Rolling Meadows Substation
Construction of a New Electrical Substation
including Grading, Drainage, and Surface Improvements
El Paso County, Colorado

EPC STORMWATER REVIEW COMMENTS
IN ORANGE BOXES WITH BLACK TEXT

PPR2619

115/12.47kV
COVER SHEET

CONCRETE OUTLET STRUCTURE
FRONT VIEW
N.T.S.

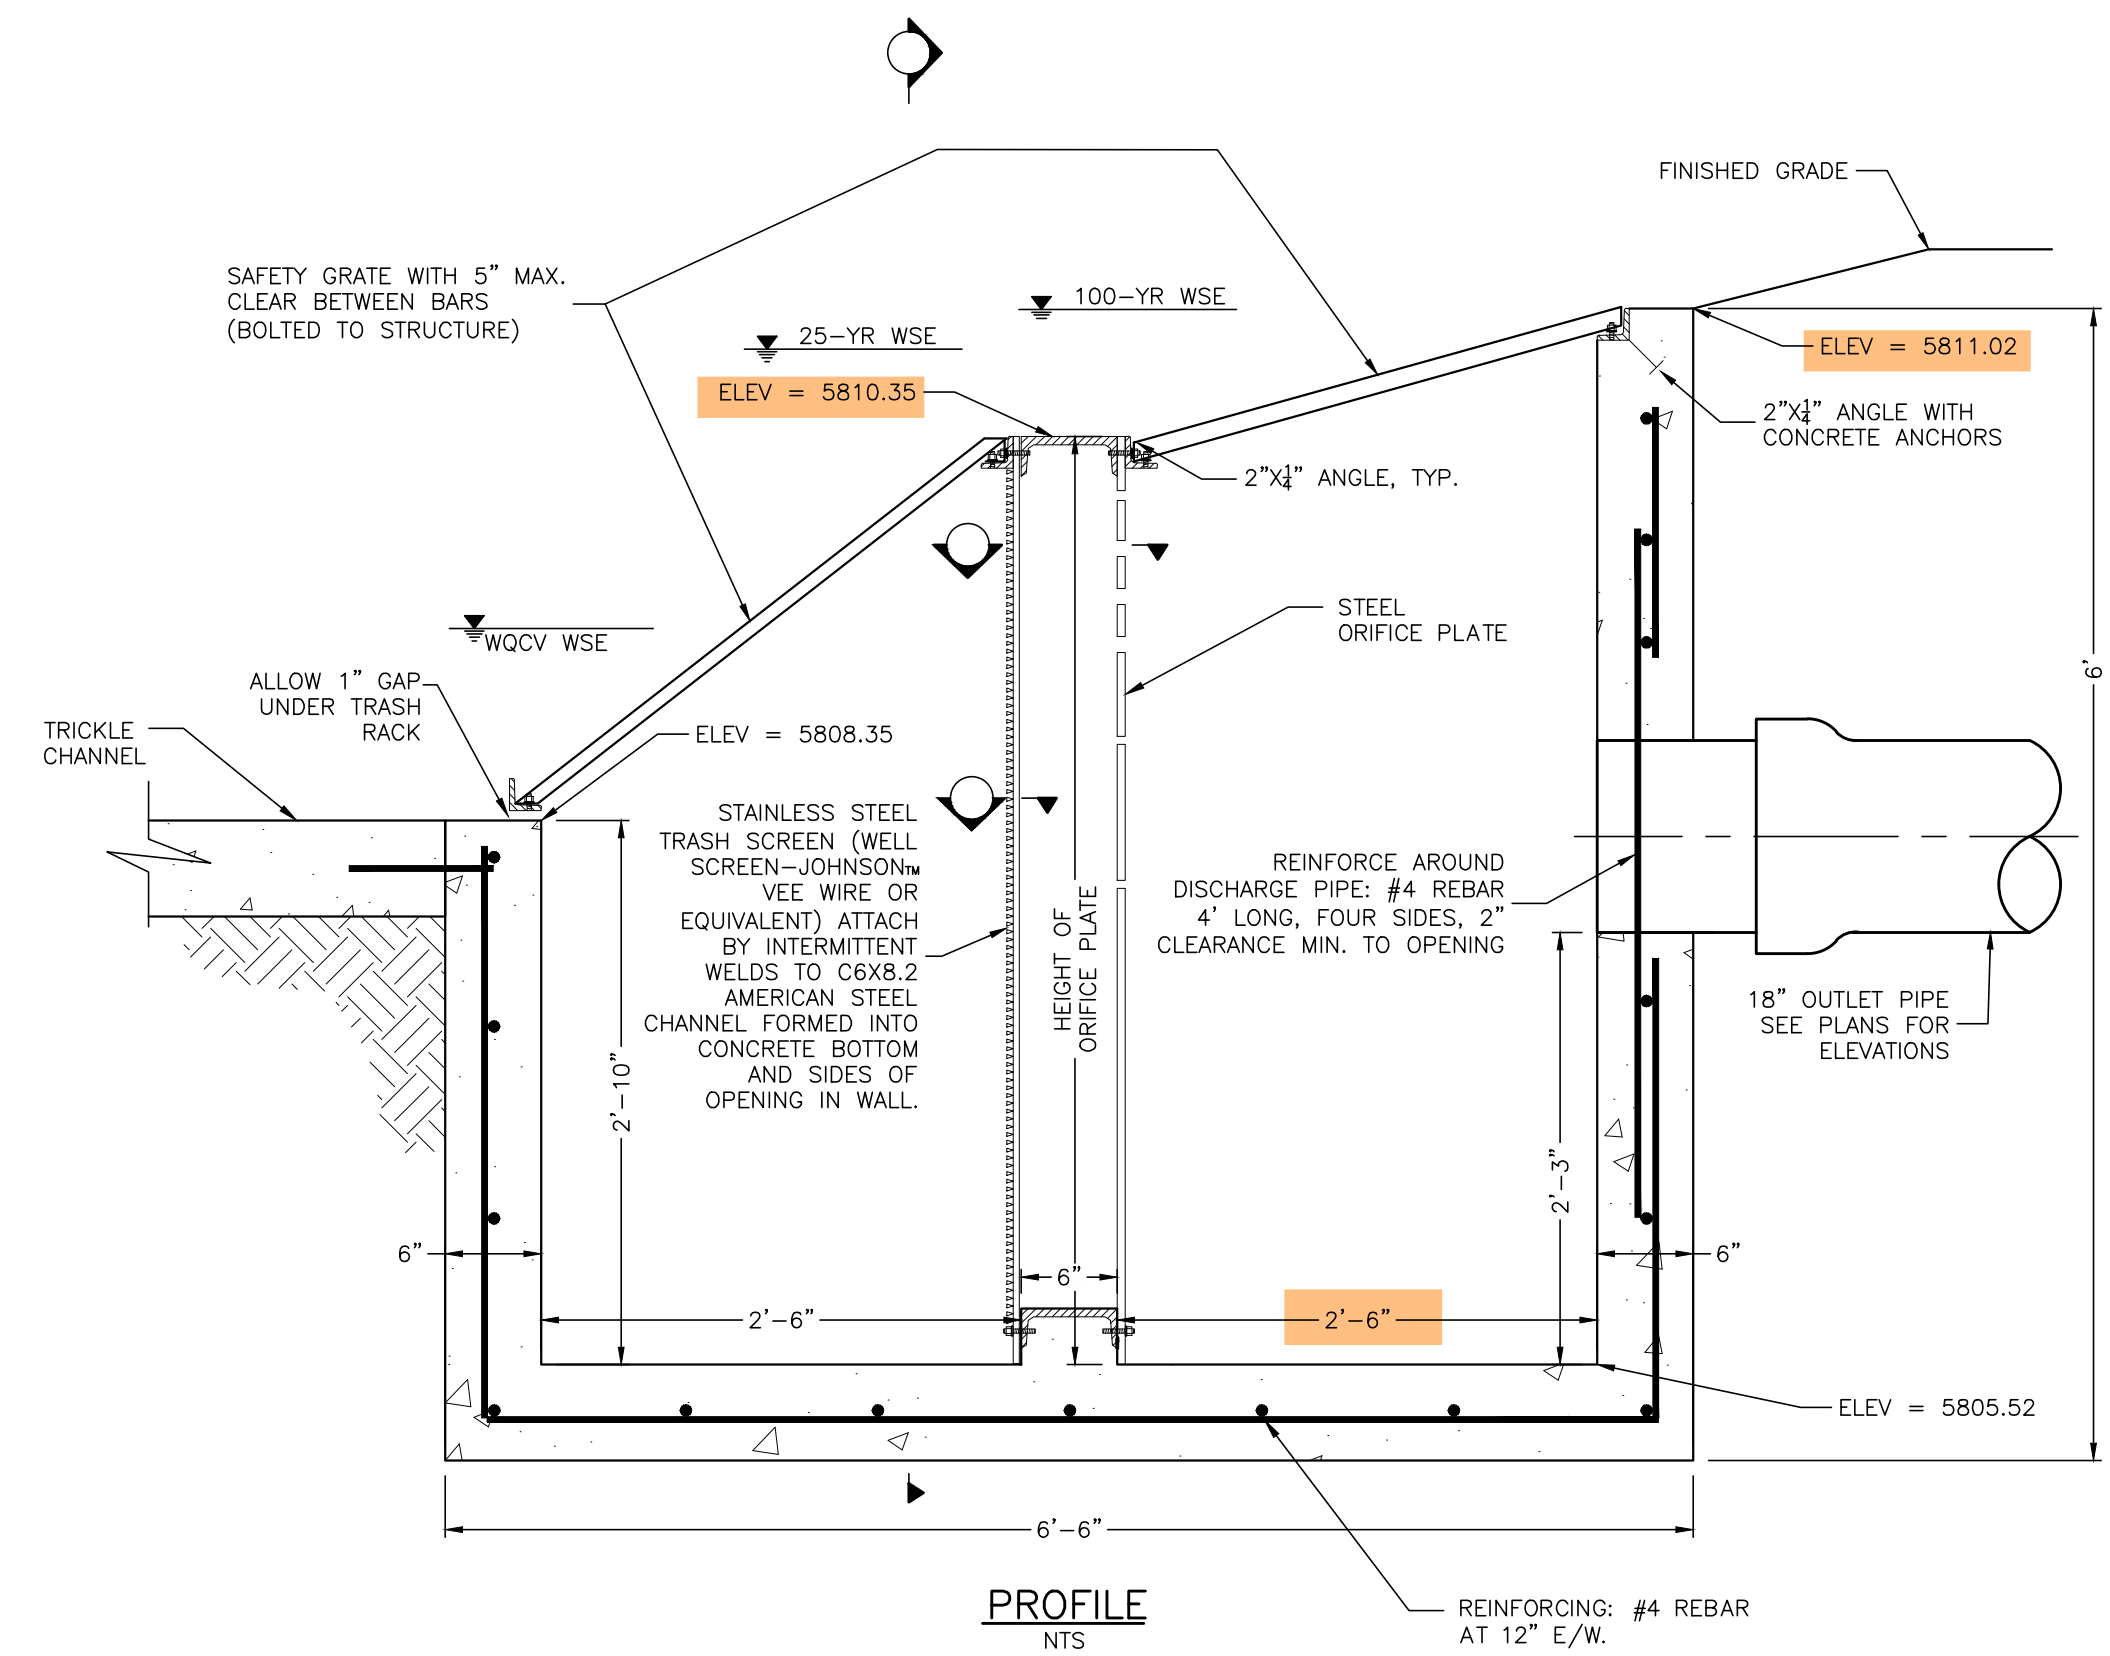
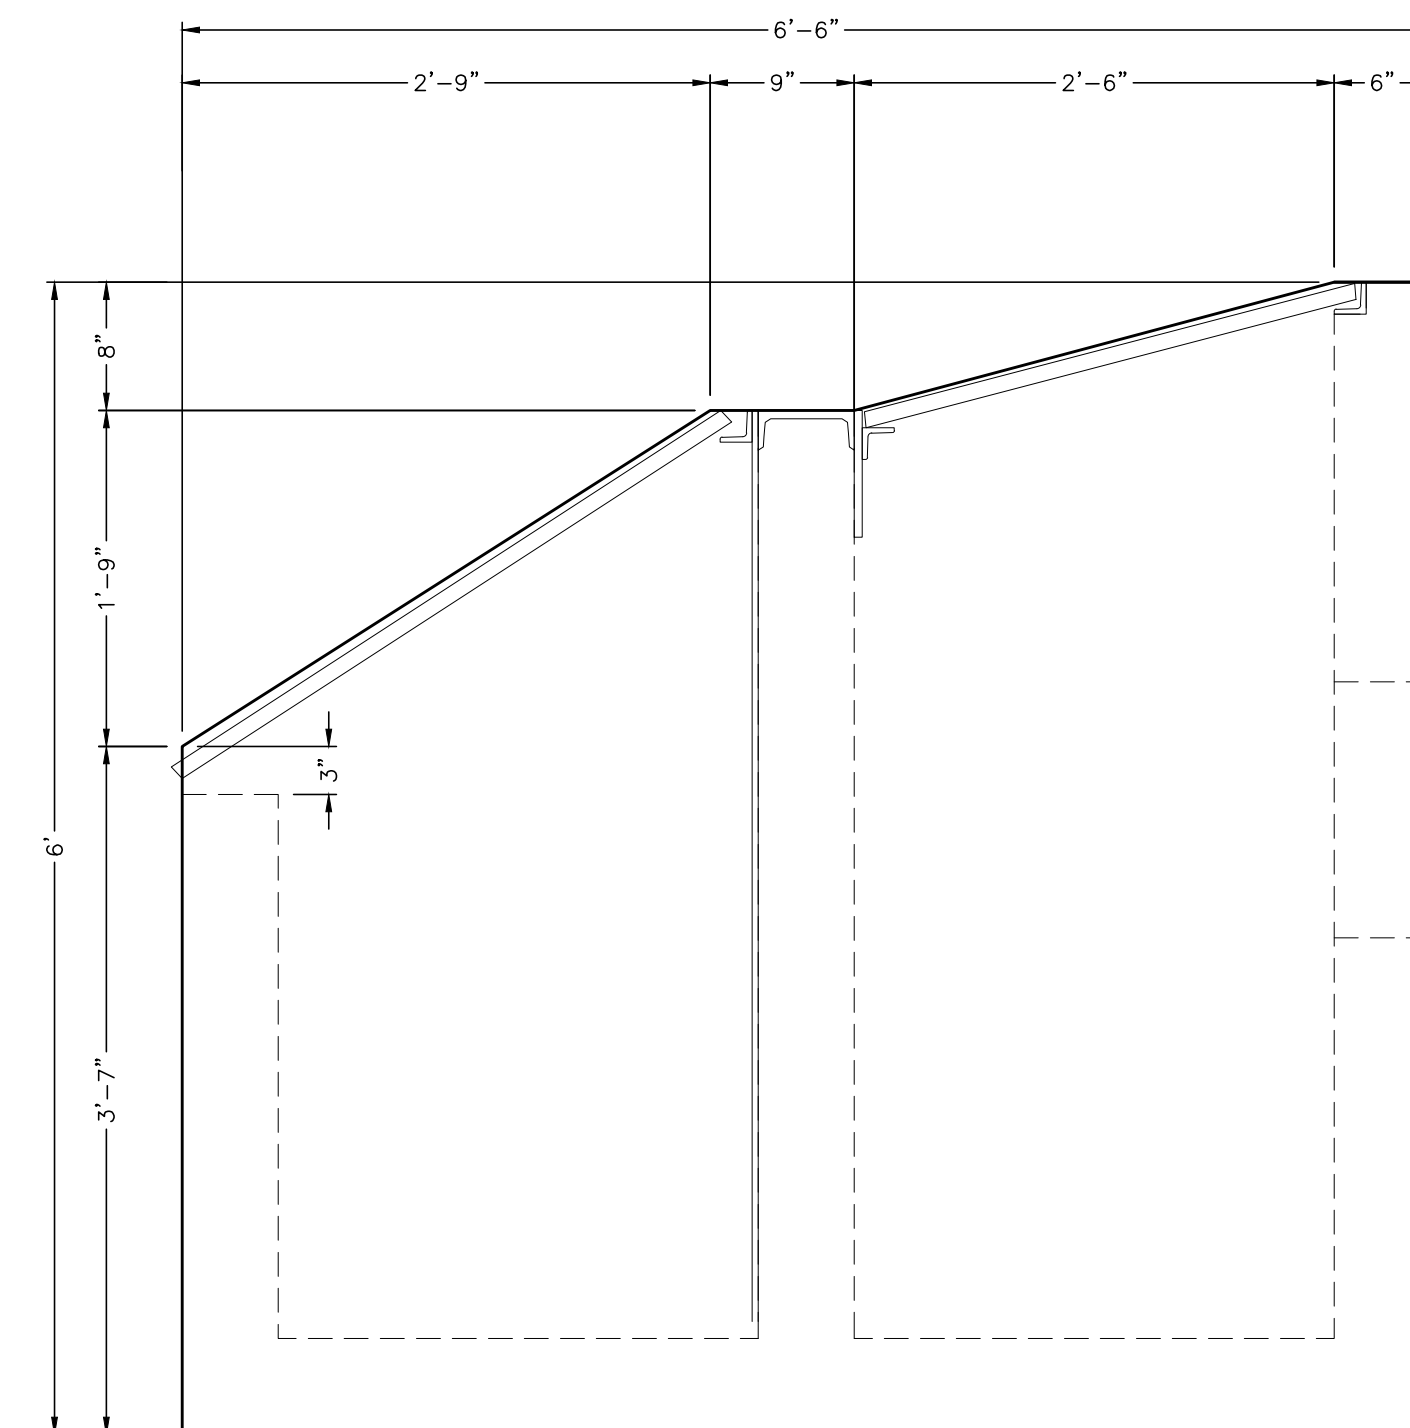
Provide detail for restrictor plat, as shown on MHFD spreadsheet

S1183-A-01-012

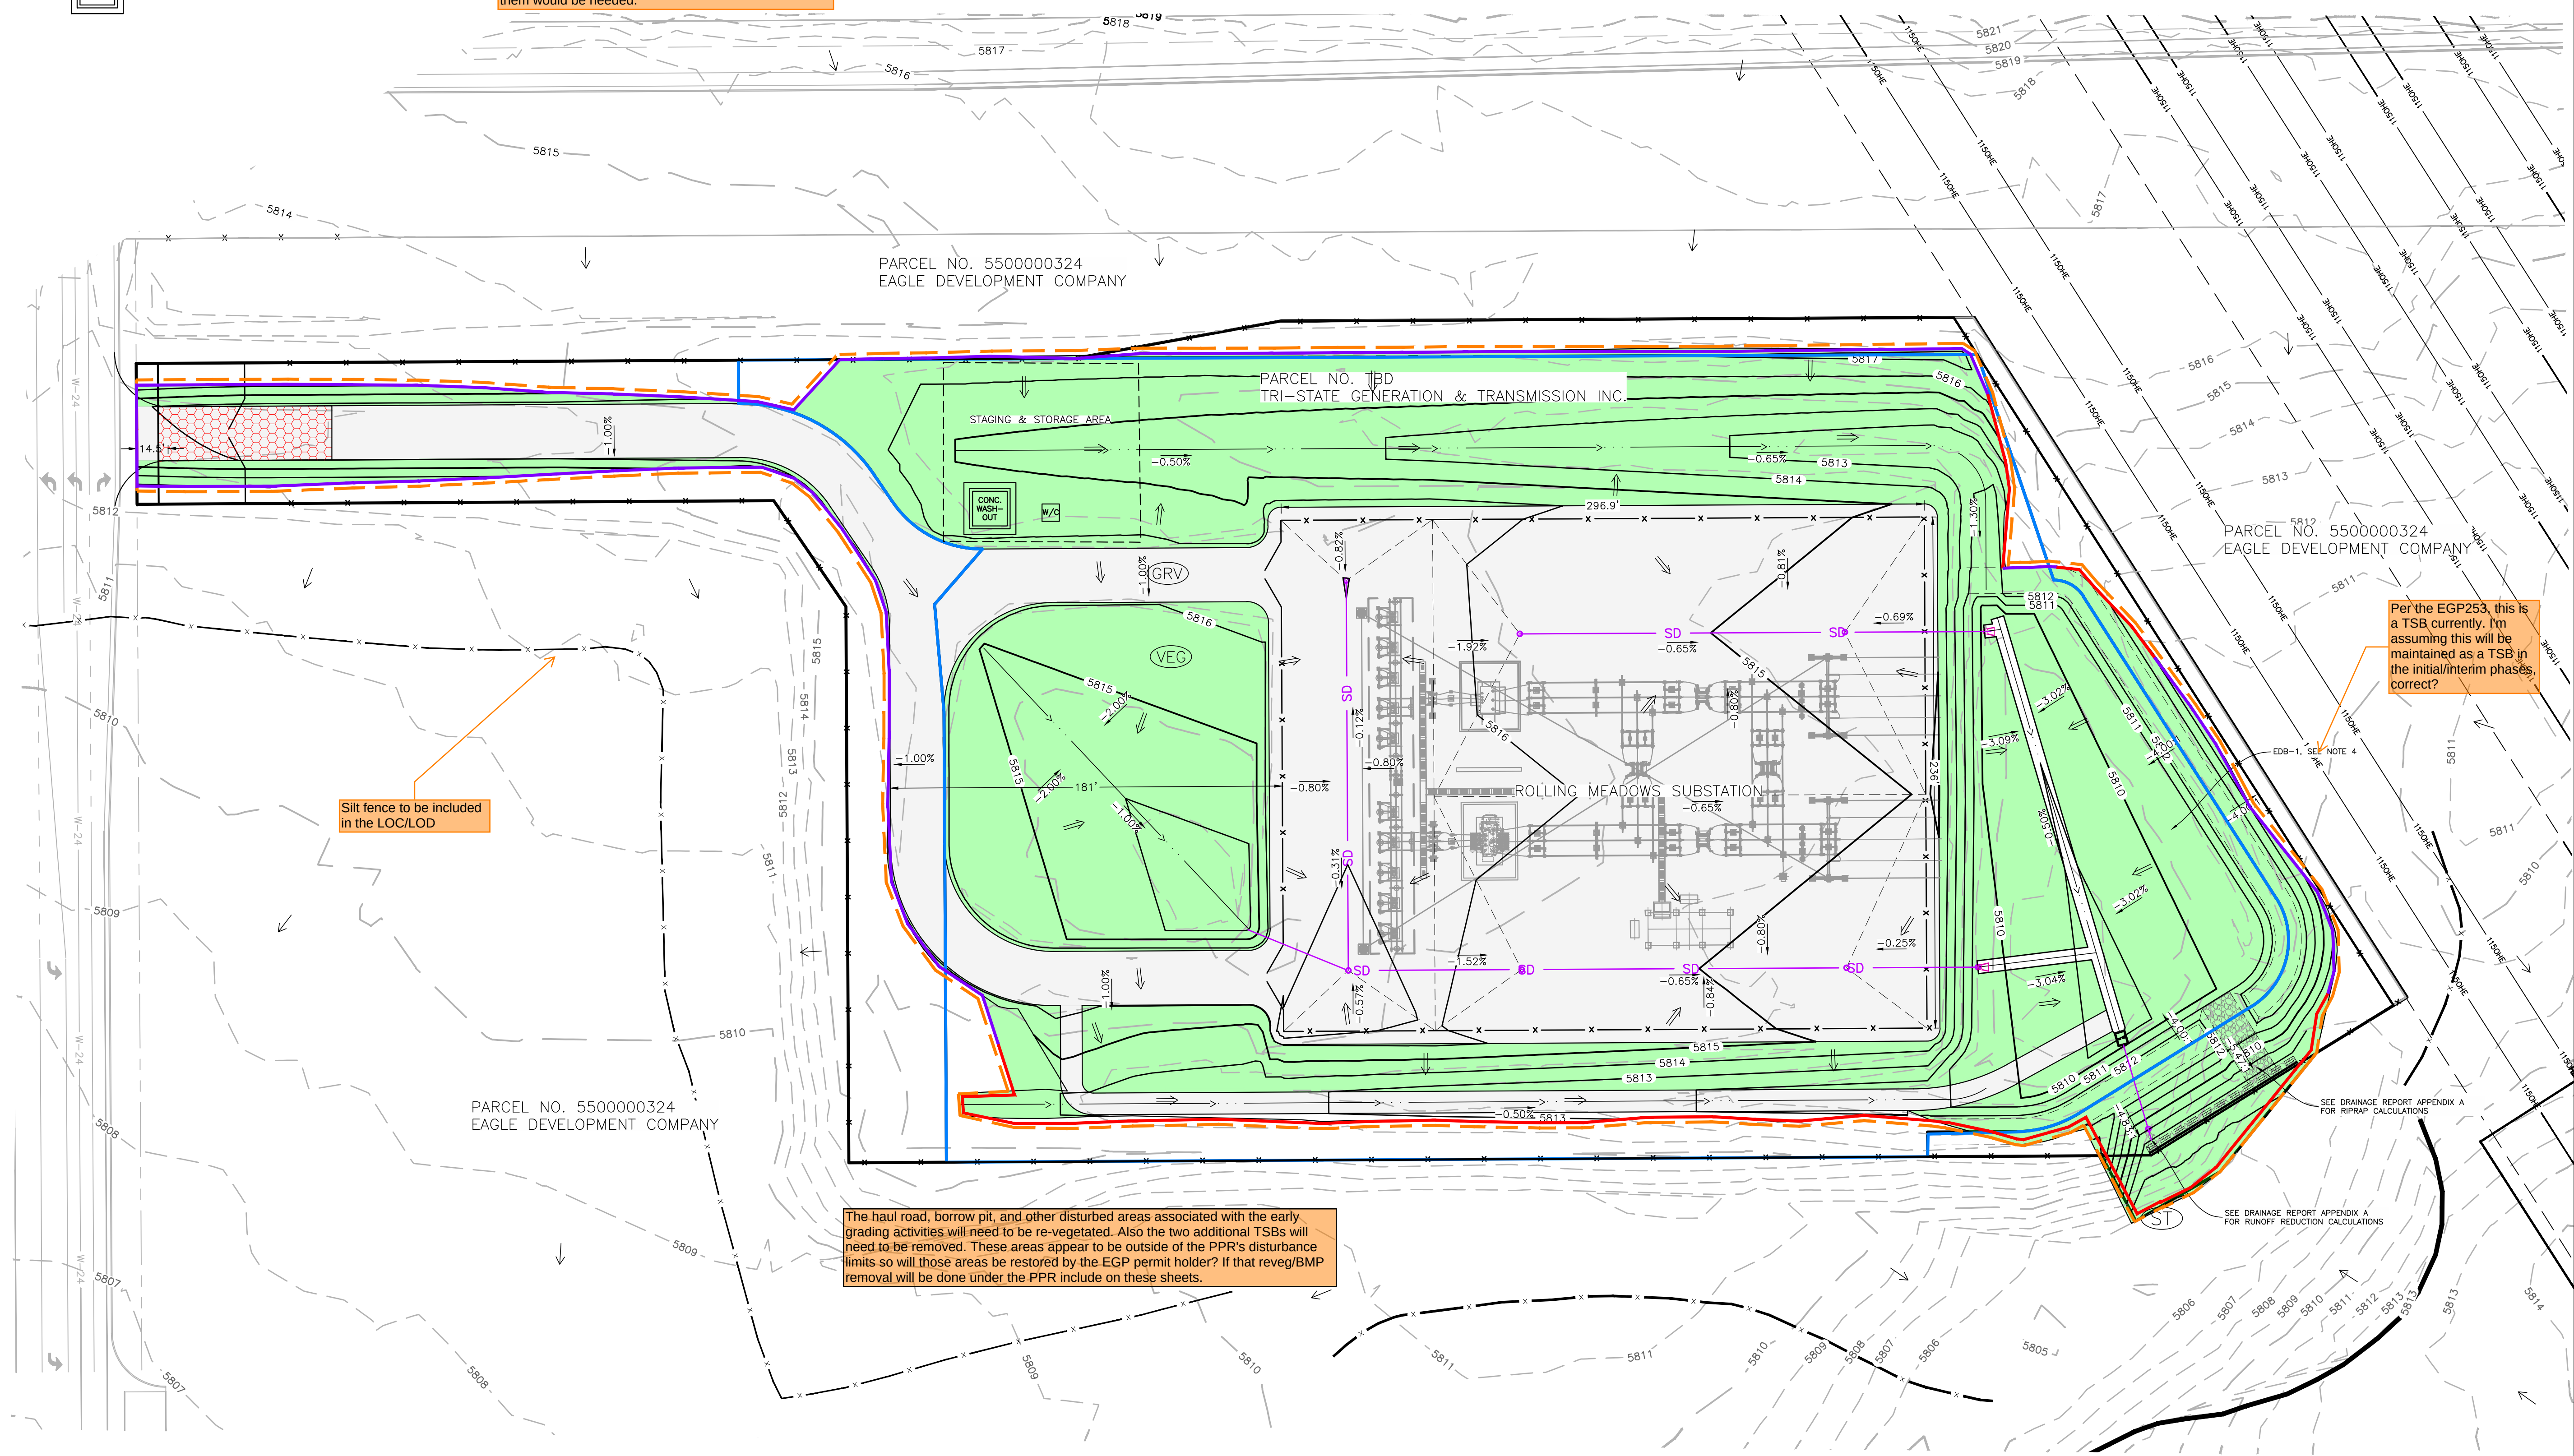
Silt fence to be included in the LOC/LOD

Per the EGP253, this is a TSB currently. I'm assuming this will be maintained as a TSB in the initial/interim phases, correct?

The haul road, borrow pit, and other disturbed areas associated with the early grading activities will need to be re-vegetated. Also the two additional TSBs will need to be removed. These areas appear to be outside of the PPR's disturbance limits so will those areas be restored by the EGP permit holder? If that reveg/BMP removal will be done under the PPR include on these sheets.
